Critiques on Stress Test Reports

Green Citizens' Action Alliance

New Taipei City, September 25th 2013

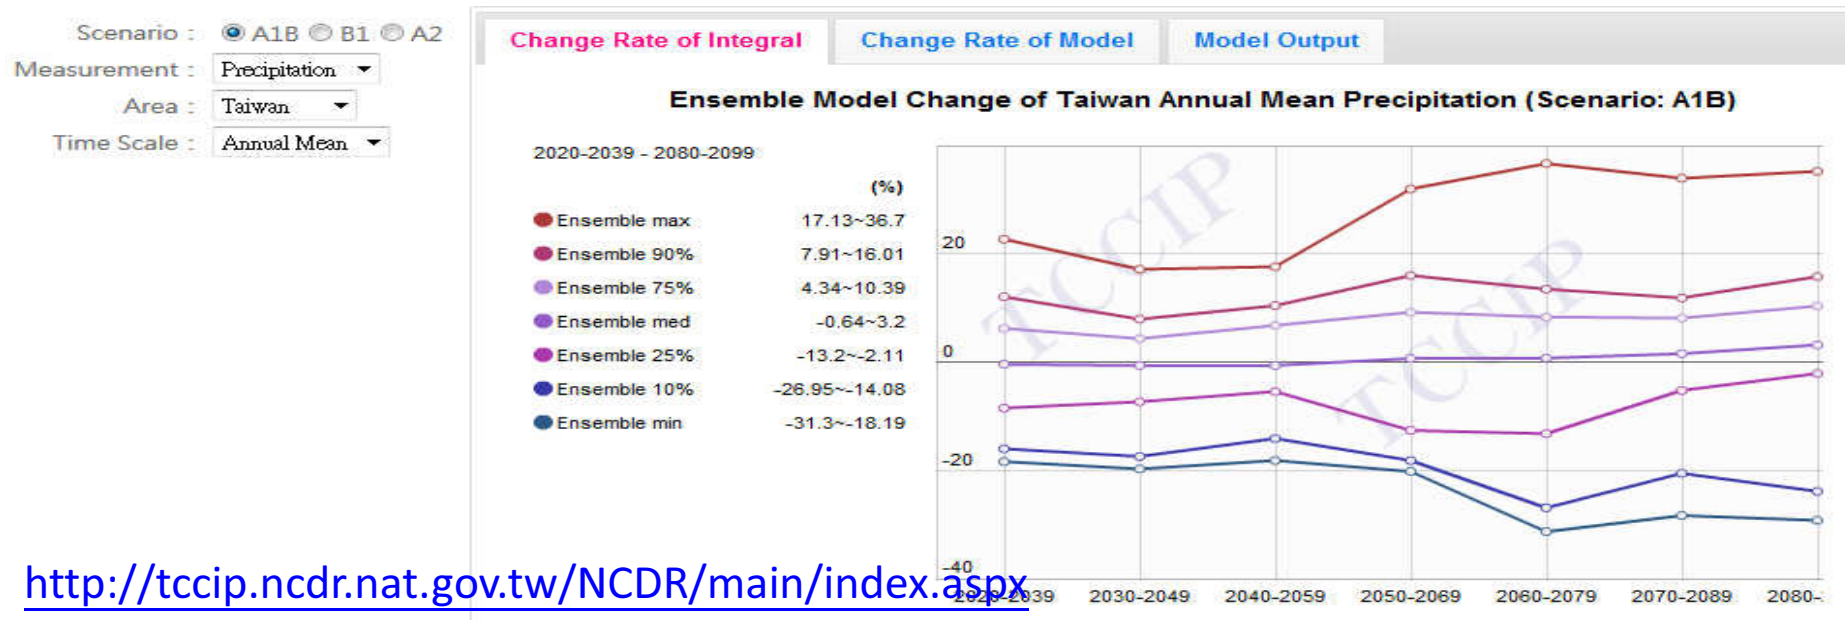
“CS: How is the PMP of 297 mm/h justified at the background of a record of 325 mm/h for a historical storm? ”

“LM: The PMP is lower than the values recorded near CS NPP (up to 325 mm/h). How is this discrepancy justified?”

- ***GCAA urge that the potential consequence of above miscalculation shouldn't be overlooked and needed to be highlighted in the final review report.***

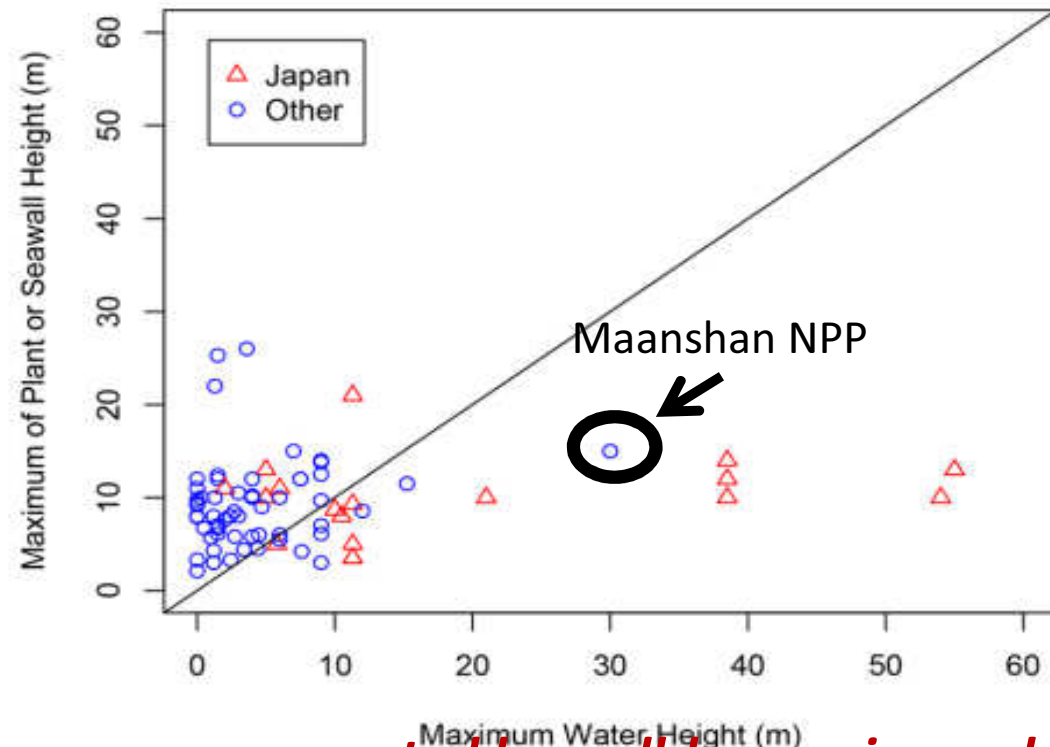
- Rodriguez-Vidal et al. 2012. Civil nuclear power at risk of tsunamis. Natural Hazard. 63:1273–1278.
 - All NPPs in Taiwan located in tsunami risk areas.

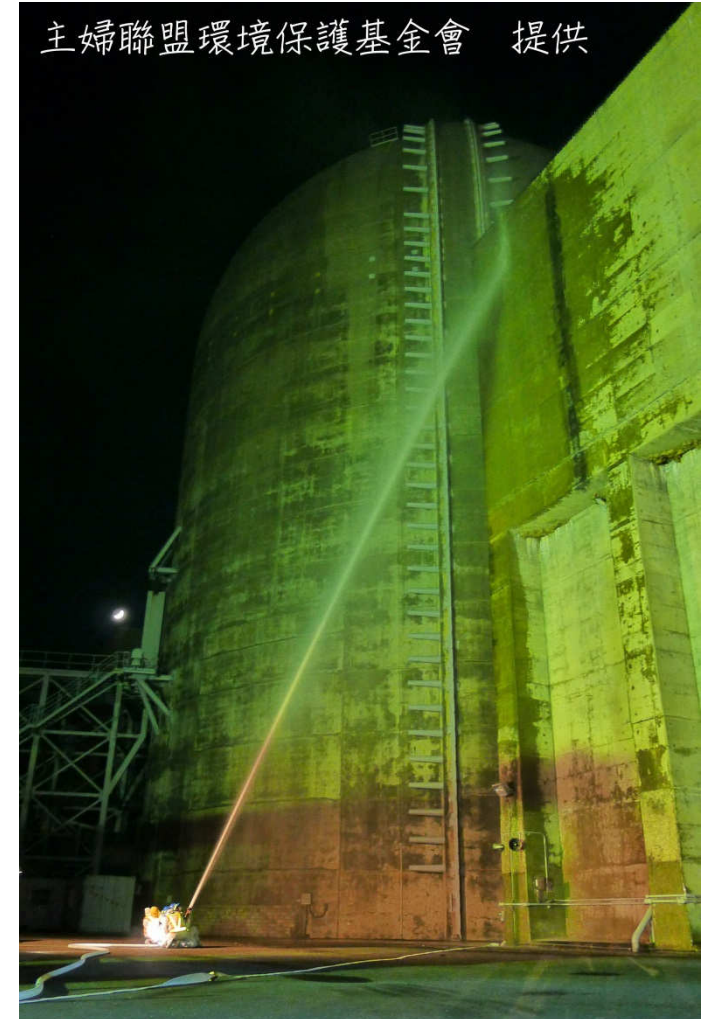
- Exercise and Drill on URG in Maanshan NPP (核三)
 - “Business as Usual” Assumption
 - Contradicting the possible scenario
